CITY OF ALBUQUERQUE

**RE: Love's Broadway/Sunport Blvd
3200 Broadway Blvd SE
30-Day Temporary C.O. – Accepted
Engineer's Certification Date: 03/11/2026
Engineer's Stamp Date: 05/29/2025
Hydrology File: M14D038
Case #: HYDR-2026-00096**

Bailey Thompson, E.I.
Engineer Associate, Hydrology
Planning Department, Development Review Services

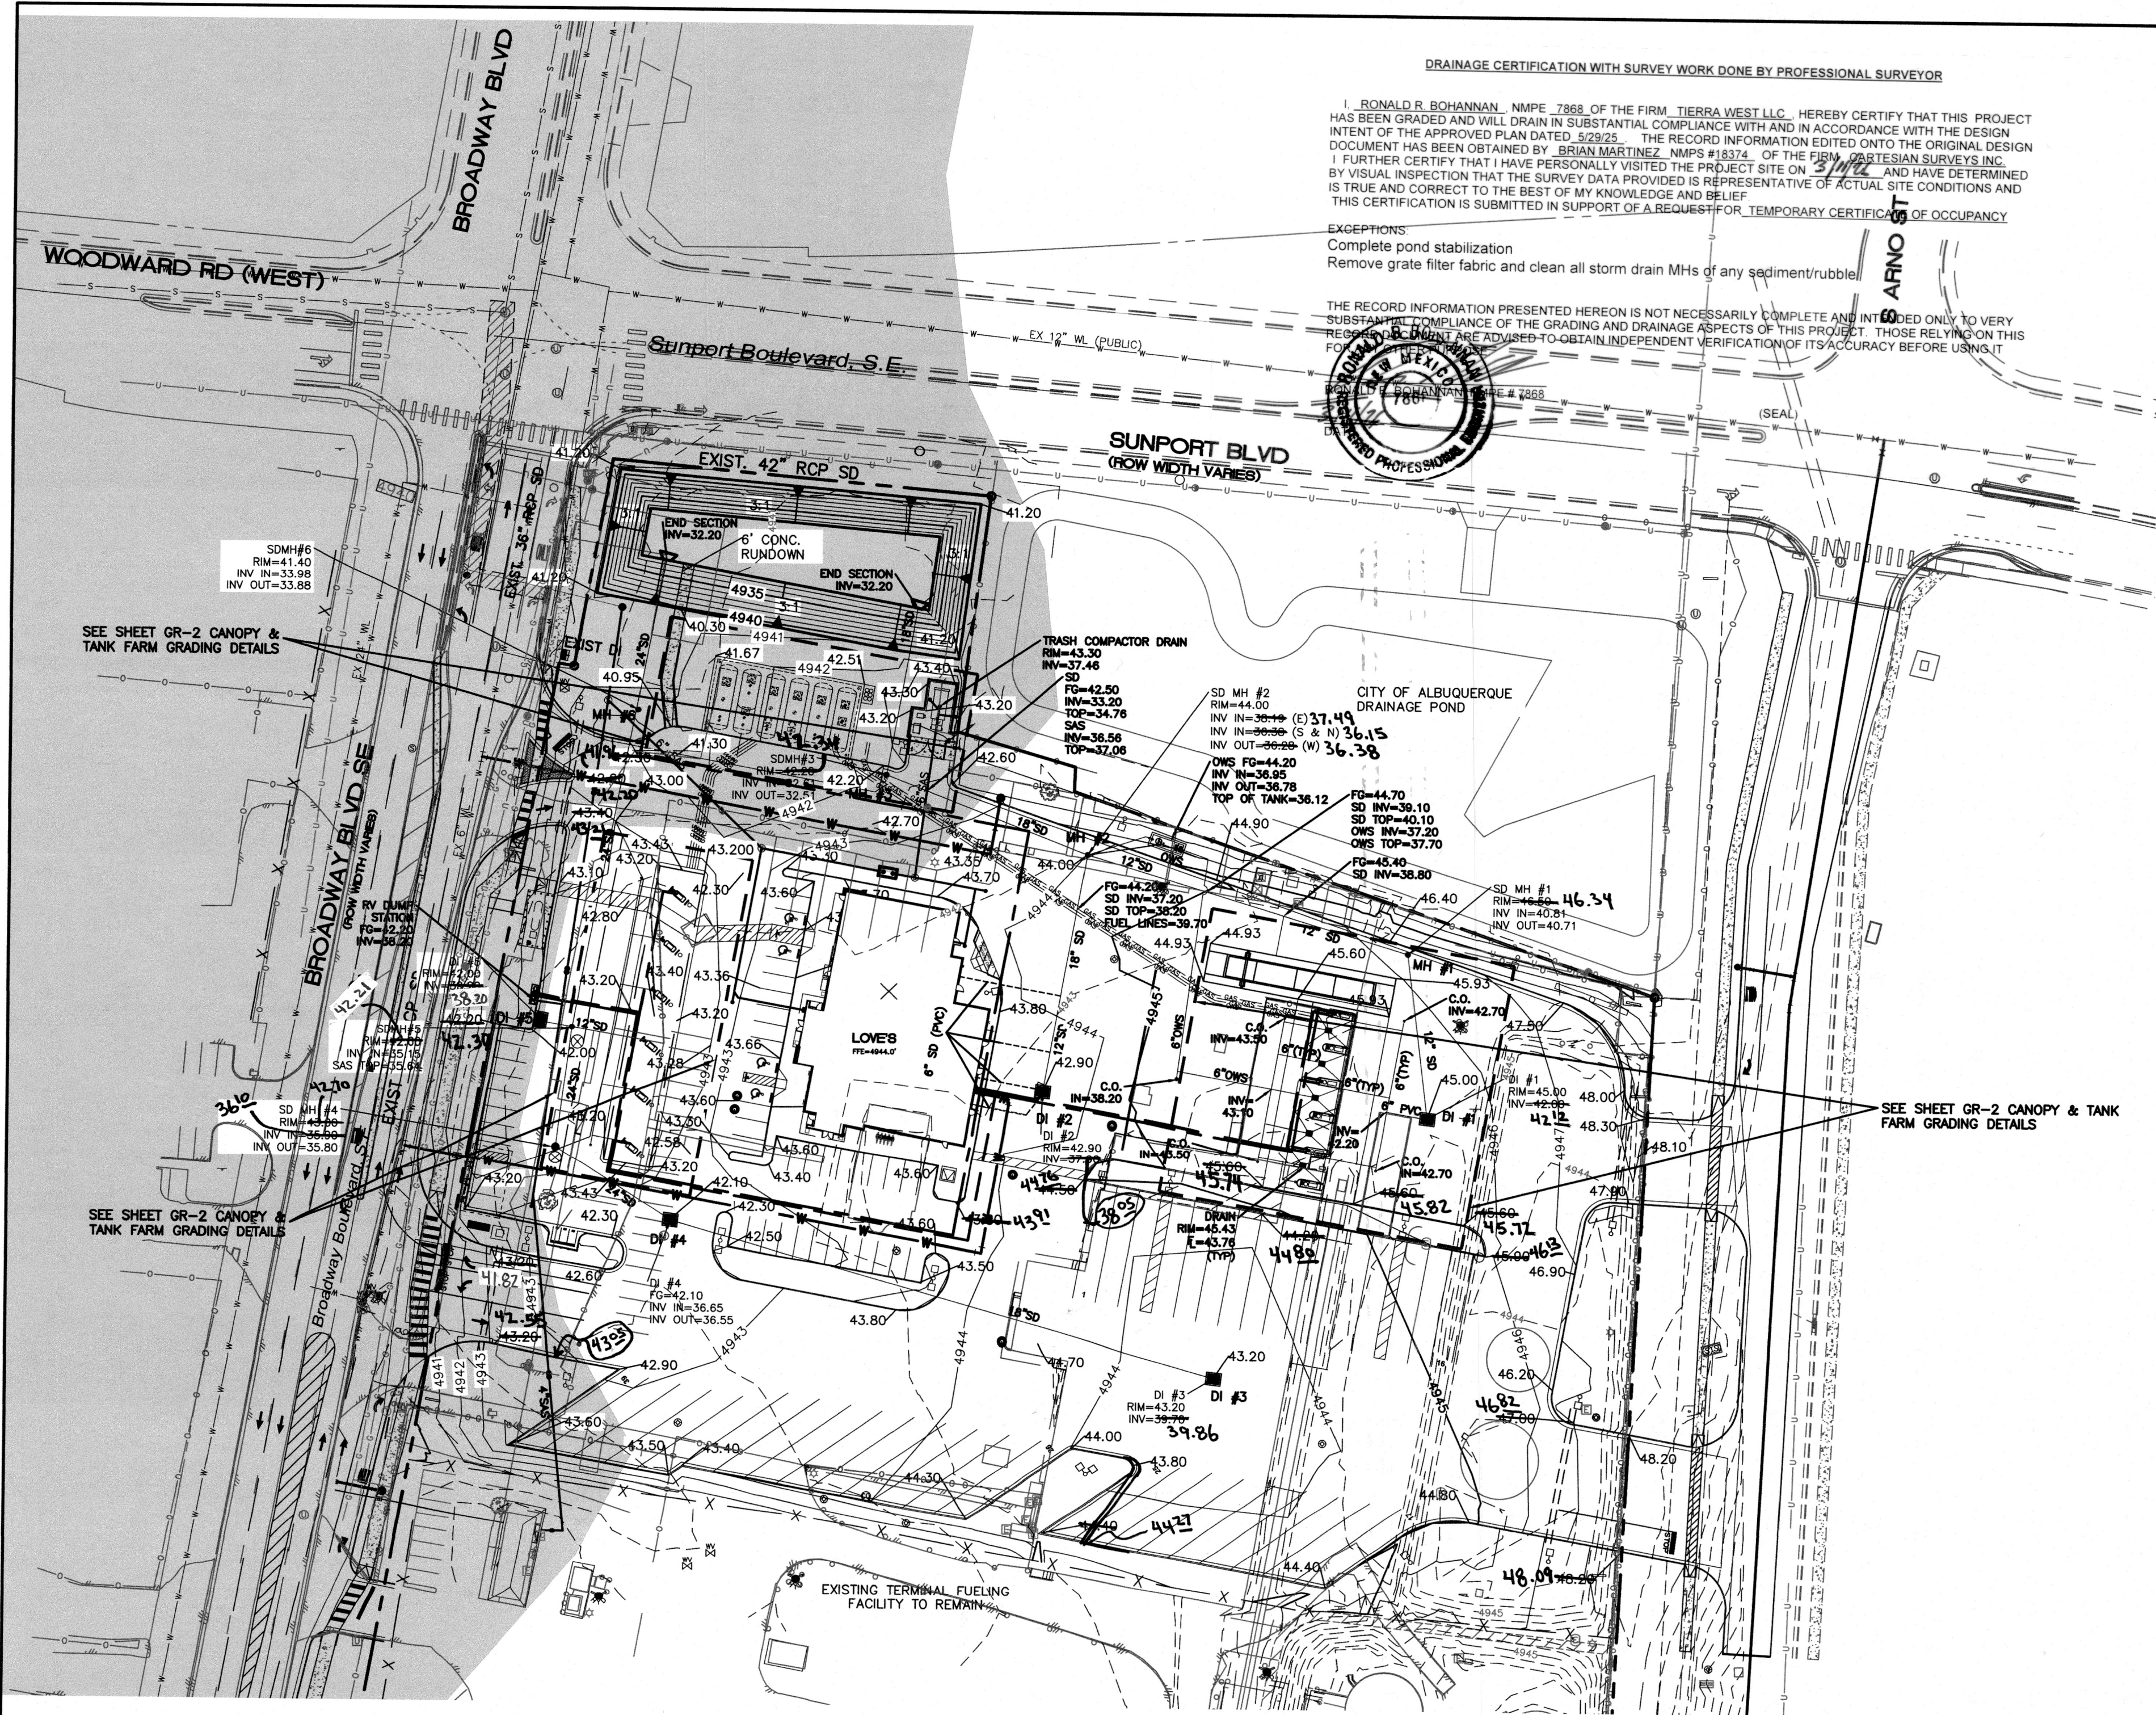
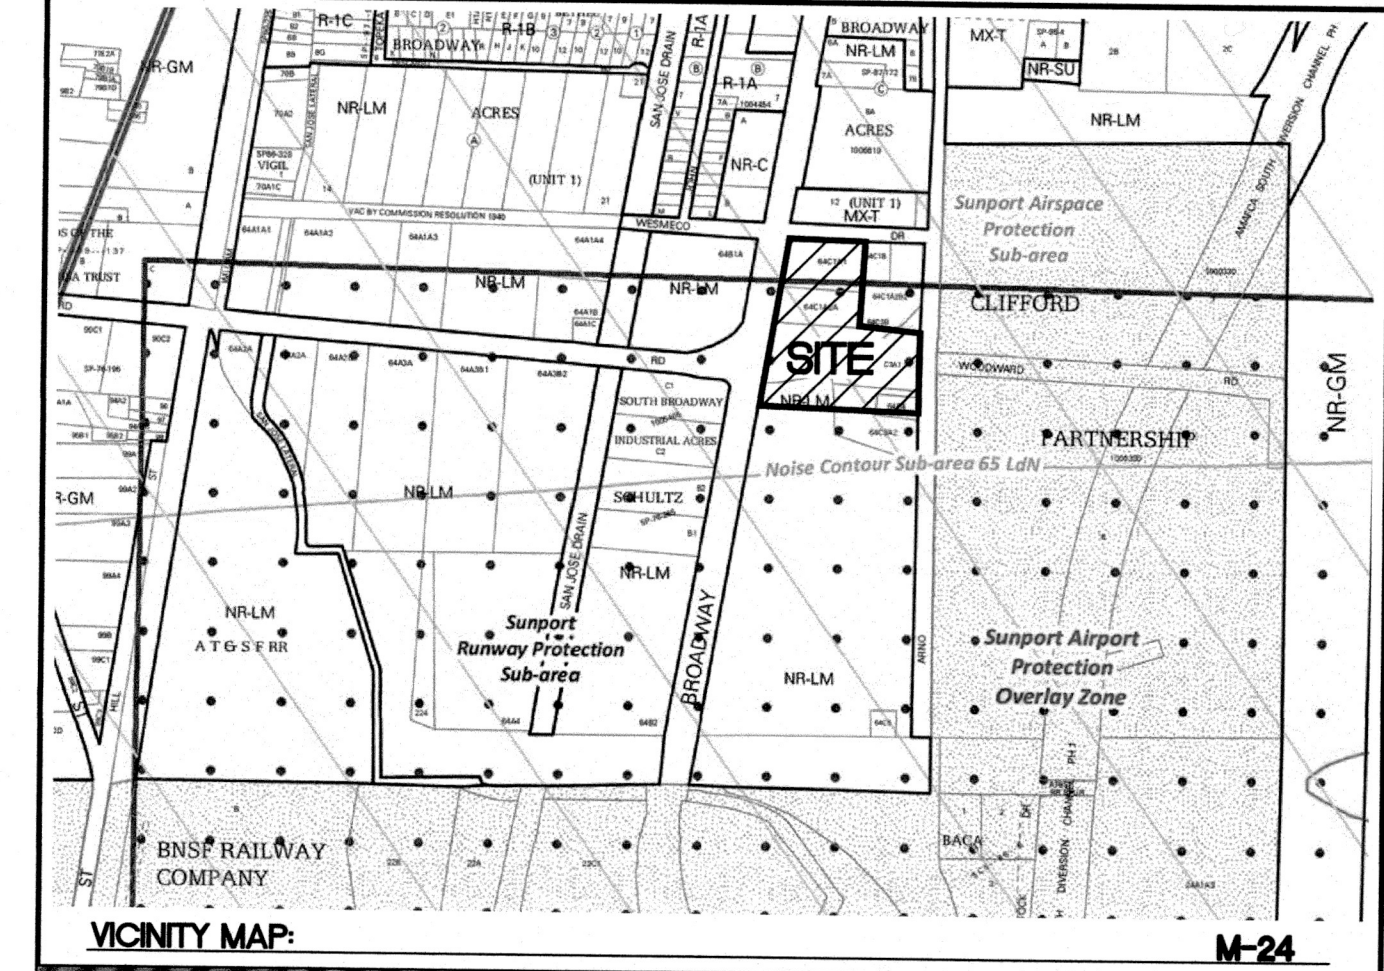
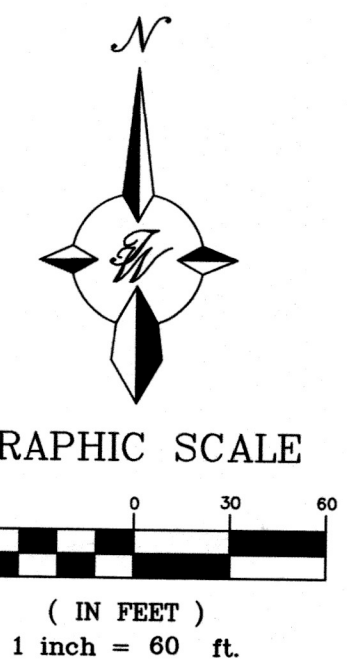
1. Side slopes of ponds need to be stabilized per construction plans and City Standard Spec 1013.
2. Provide the executed paper Drainage Covenant (latest revision) printed on one-side only with Exhibit A and a check for \$25.00 make out to "Bernalillo County" for the stormwater quality ponds per Article 6-15(C) of the DPM to Hydrology for review at Plaza del Sol. Additionally, please submit the Drainage Covenant to ABQ-Plan.

EXCEPTIONS:
 Complete pond stabilization
 Remove grate filter fabric and clean all storm drain MHS of any sediment/rubble
